## **BDM Revisions**

### **7.4 Column Reinforcement**

**Revision Description:**

This memorandum revises WSDOT column reinforcement in accordance with AASHTO LRFD SGS requirements, and in accordance with knowledge acquired from the January 2014 NHI Seismic Training course in Washington.

Figure 7.4.4-1

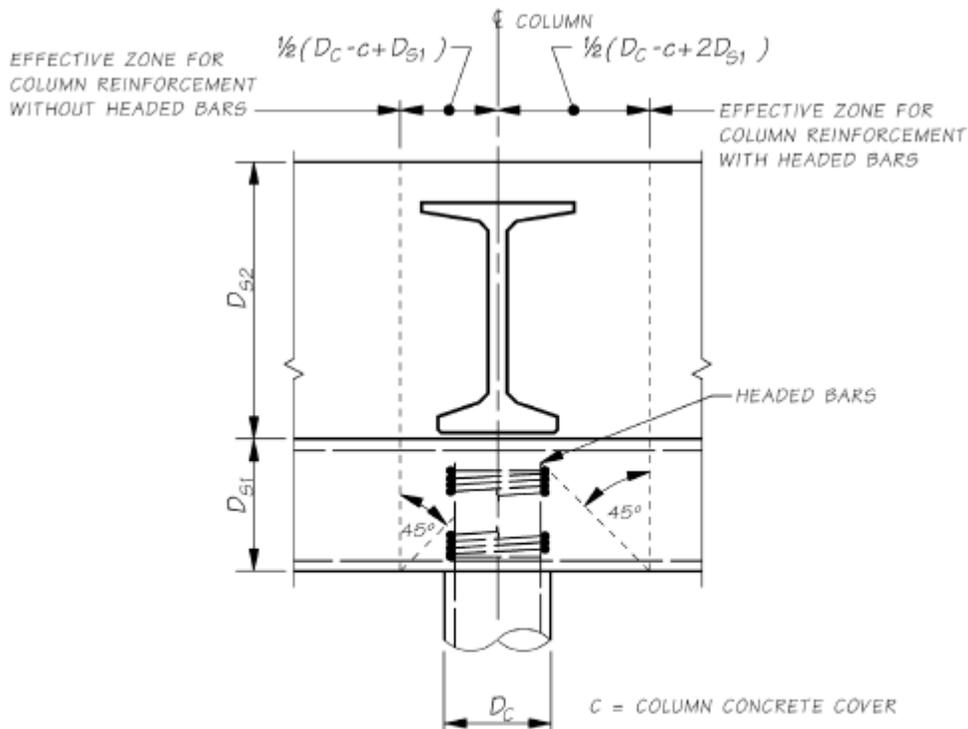
For precast prestressed concrete girder bridges in SDCs C and D with two-stage fixed diaphragms at intermediate piers, all column longitudinal reinforcement should extend to the top of the cast-in-place concrete diaphragm (upper crossbeam) above the lower crossbeam. Careful attention should be given that column reinforcement does not interfere with extended strands projecting from the end of the prestressed concrete girders. In case of interference, column longitudinal reinforcement obstructing the extended strands may be terminated at top of the lower crossbeam, and shall be replaced with equivalent full-height stirrups extending from the lower to upper crossbeam within the effective width as shown in Figure 7.4.4-1. All stirrups within the effective zone, based on an approximate strut-and-tie model, may be used for this purpose. The effective zone shall be taken as column diameter plus depth of lower crossbeam provided that straight column bars are adequately developed into the lower crossbeam. The effective zone may be increased to the column diameter plus two times depth of lower crossbeam if headed bars are used for column longitudinal reinforcement.

If the depth of lower crossbeam is less than 1.25 times the tension development length required for column reinforcement, headed bars shall be used. Heads on column bars terminated in the lower crossbeam are preferable from a structural perspective. However, extra care in detailing during design and extra care in placement of the column reinforcement during construction is required. Typically the heads on the column bars will be placed below the lower crossbeam top mat of reinforcement. Headed reinforcement shall conform to the requirements of ASTM 970 Class HA.

Transverse column reinforcement only needs to extend to the top of the lower crossbeam just below the top longitudinal steel. However, when the joint shear principal tension is less than  $0.11\sqrt{f'_c}$ , minimum cross tie reinforcement shall be placed acting across the upper cross beam in accordance with the AASHTO Seismic 8.13.3. The minimum cross tie reinforcement shall provide at least as much confining pressure at yield as the column spiral can provide at yield. This pressure may be calculated assuming hydrostatic conditions. If the joint shear principal tension exceeds  $0.11\sqrt{f'_c}$ , then additional joint reinforcement as outlined by AASHTO Seismic 8.13.3 shall be provided. With the exception of J-bars, the additional reinforcement shall be placed in the upper and lower crossbeam. The cross tie reinforcement may be placed with a lap splice in the center of the joint.

The designer is encouraged to include interference detail/plan views of the crossbeam reinforcement in relation to the column steel in the contract drawings. Suggested plans

include the views at the lower stage crossbeam top reinforcement and the upper crossbeam top reinforcement.

*Figure 7.4.4-2*

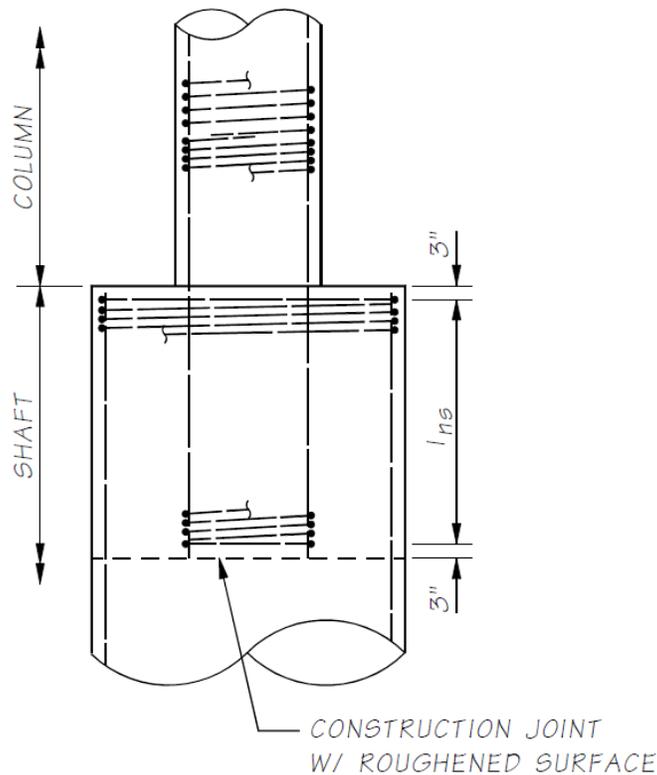
- C. **Shafts** – Column longitudinal reinforcement in shafts is typically straight. Embedment shall be a minimum length equal to  $l_{ns} = l_s + s$  (per TRAC Report WA-RD 417.1 titled

- $l_s$  = the larger of  $1.7 \times l_{ac}$  or  $1.7 \times l_d$  (for Class C lap splice) where:
- $l_{ac}$  = development length from the Seismic Guide Spec. 8.8.4 for the column longitudinal reinforcement.
- $l_d$  = tension development length from AASHTO LRFD Section 5.11.2.1 for the column longitudinal reinforcement.
- $s$  = distance between the shaft and column longitudinal reinforcement

See Figure [7.4.4-2](#) for an example of longitudinal development into shafts. Section 7.8.2-K provides additional requirements for transverse shaft reinforcement to confine the non-contact lap splice.

Figure 7.4.5-1

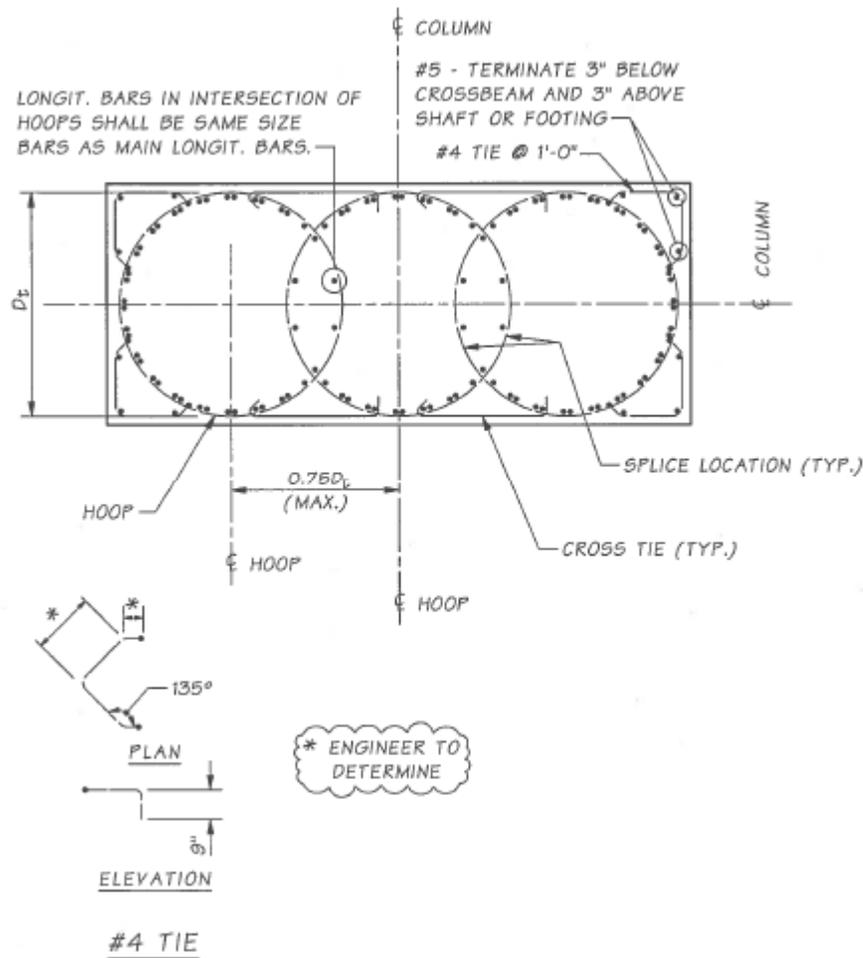
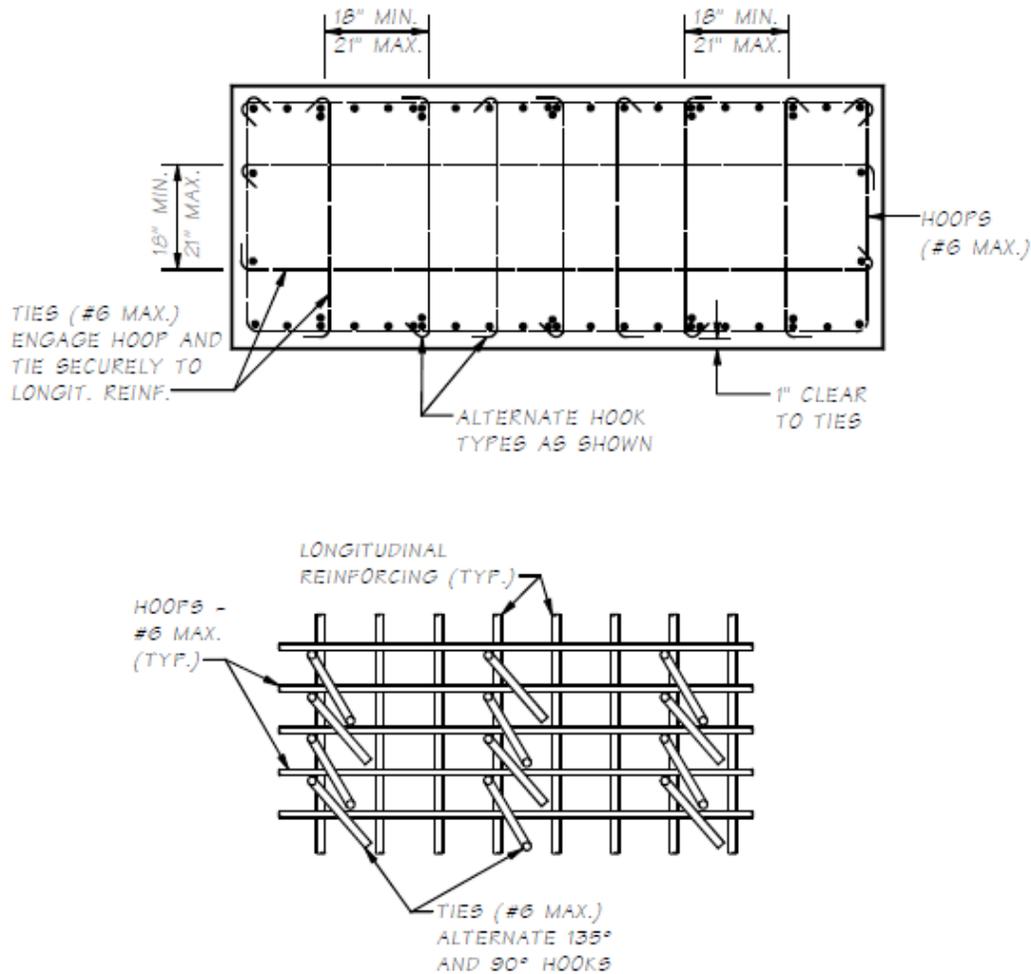
Columns in SDCs A and B may use spirals, circular hoops, or rectangular hoops and cross-ties. Spirals are the preferred confinement reinforcement and shall be used whenever a #6 spiral is sufficient to satisfy demands. When demands require reinforcement bars greater than #6, circular hoops of #7 through #9 may be used. Bundled spirals shall not be used for columns or shafts. Also, mixing of spirals and hoops within the same column is not permitted by the AASHTO Seismic Specifications. [Figure 7.4.5-1](#) and [7.4.5-2](#) show transverse reinforcement details for rectangular columns in high and low seismic zones, respectively.

Columns in SDCs C and D shall use circular hoop reinforcement where possible, although rectangular hoops with ties may be used when large, odd shaped column sections are required. Where the column diameter is 3-feet or less, the WSDOT Steel Specialist shall be contacted regarding the constructability of smaller diameter welded hoops.

When rectangular hoops with ties are used, consideration shall be given to column

constructability. Such considerations can include, but are not limited to a minimum of 2'-6" by 3'-0" open rectangle to allow access for the tremie tube and construction workers for concrete placement, in-form access hatches, and/or external vibrating.

Figure 7.4.5-3

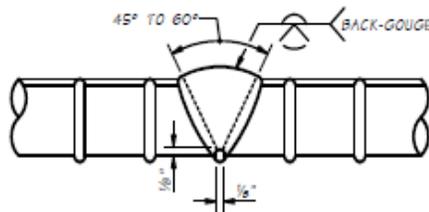
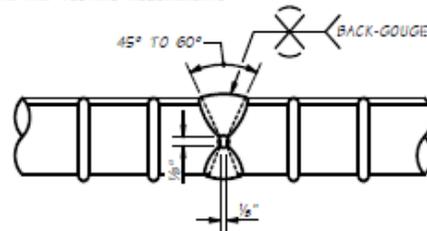
- B. **Spiral Splices and Hoops** – Welded laps shall be used for splicing and terminating spirals and shall conform to the details shown in Figure 7.4.5-3. Only single sided welds shall be used, which is the preferred method in construction. Spirals or butt-welded hoops are required for plastic hinge zones of columns. Lap spliced hoops are not permitted in columns in any region.

When welded hoops are used, the plans shall show a staggered pattern around the perimeter of the column so that no two adjacent welded splices are located at the same location. Also, where interlocking hoops are used in rectangular or non-circular columns, the splices shall be

Circular hoops for columns shall be shop fabricated using a manual direct butt weld or resistance butt weld. Currently, a Bridge Special Provision has been developed to cover the fabrication requirements of hoops for columns and shafts, which may eventually be included in the *Standard Specifications*. Manual direct butt welded hoops require radiographic nondestructive examination (RT), which may result in this option being cost prohibitive at large quantities.

Columns with circular hoop reinforcement shall have a minimum 2" concrete cover to the hoops to accommodate resistance butt weld "weld flash" that can extend up to ½" from the bar surface.

Field welded lap splices and termination welds of spirals of any size bar are not permitted in the plastic hinge region including a zone extending 2'-0" into the connected member and should be clearly designated on the contract plans. If spirals are welded while in place around longitudinal steel reinforcement, there is a chance that an arc can occur between the spiral and longitudinal bar. The arc can create a notch that can act as a stress riser and may cause premature failure of the longitudinal bar when stressed beyond yield. Because high strains in the longitudinal reinforcement can penetrate into the connected member, welding is restricted in the first 2'-0" of the connected member as well. It would be acceptable to field weld lap splices of spirals off to the side of the column and then slide into place over the longitudinal reinforcement.
